## WATER RESOURCES DEPARTMENT

Date: August 25, 2016TO: Application: G-18300FROM: GW: Aurora Bouchier  
(Reviewer's Name)SUBJECT: Scenic Waterway Interference & General/Local Surface Water  
Evaluation for Deschutes Ground Water Study AreaThe source of appropriation is within or above the Lower Crooked River  
Scenic Waterway.

TO: Water Rights Section Date August 25, 2016  
 FROM: Groundwater Section Aurora C Bouchier  
Reviewer's Name  
 SUBJECT: Application G- 18300 Supersedes review of an  
Date of Review(s)

**A. GENERAL INFORMATION:** Applicant's Name: Legacy Ranches LLC County: Crook

Water-Level Trends in Nearby Wells

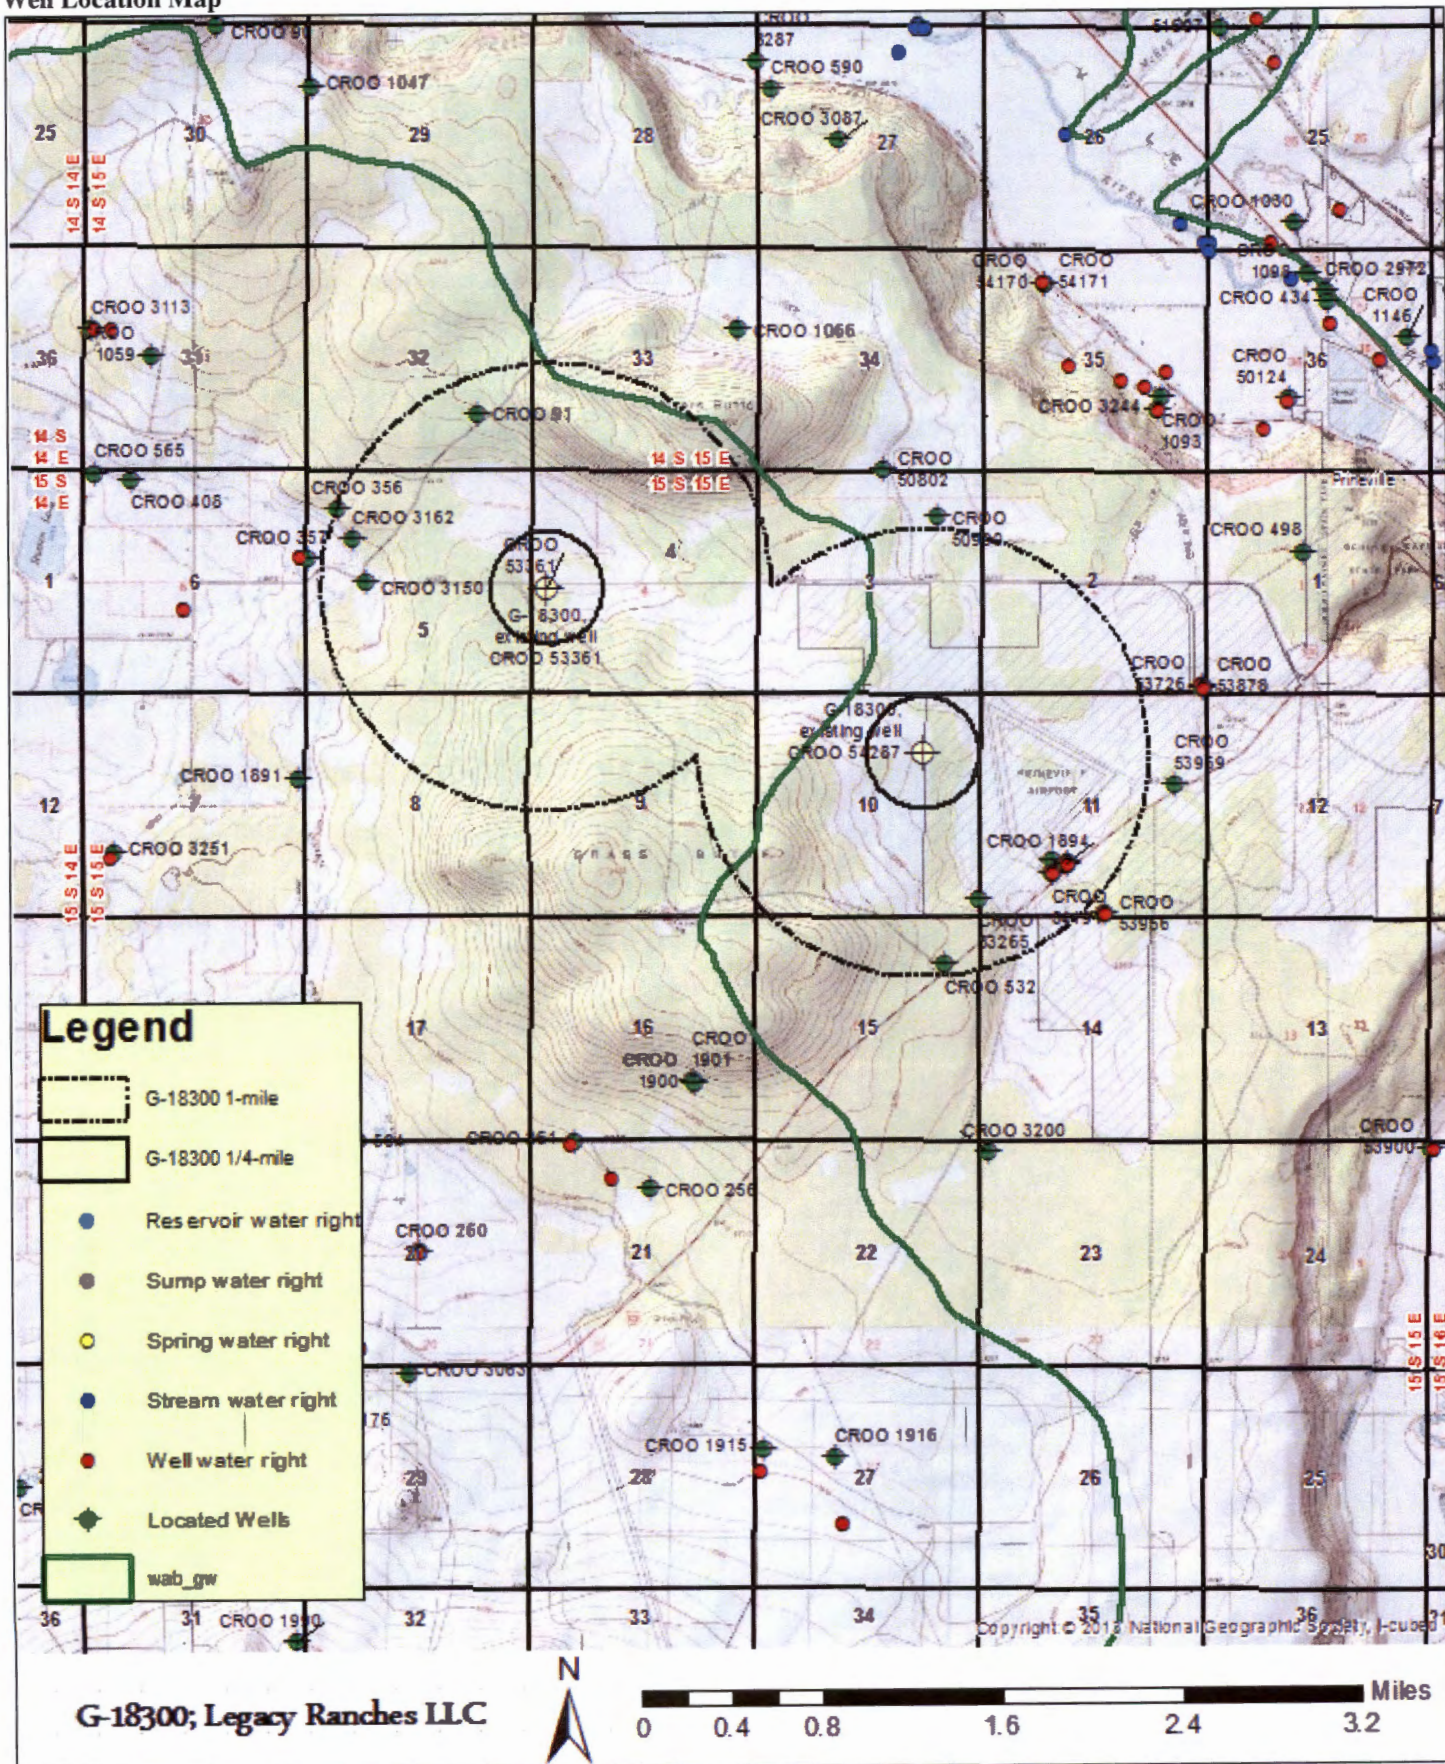
The nearest State Observation Well (Obs Well 1314, CROO 1954) is located approximately 4 miles to the southwest of CROO 54287, and approximately 3.8 miles to the south-southwest of CROO 53361. CROO 1954 has been monitored since 1994. The long term trend shows that between 1994 and 2013 the water level declined about 70 feet, likely as a result of decreased recharge and likely increased groundwater pumping in the area (Gannett and Lite, 2013). Since 2013 the water level has risen approximately 5 feet.

CROO 53361 was monitored frequently between 2008 and 2014. Over that period, the water level rose approximately 2 feet. Other wells in the area (CROO 50802 and CROO 50990) have been essentially stable since 2007, while others (CROO 53726 and CROO 53878) have shown drastic declines since monitoring began – although multiple lines of evidence suggest these two wells are completed within an intracanyon lava flow that is bounded by mostly low permeability material (Groundwater review for App G-17338) (see hydrograph below).

The hydrogeologic data in the area indicate that there are sharp permeability boundaries that are likely to exacerbate interference and water supply problems.
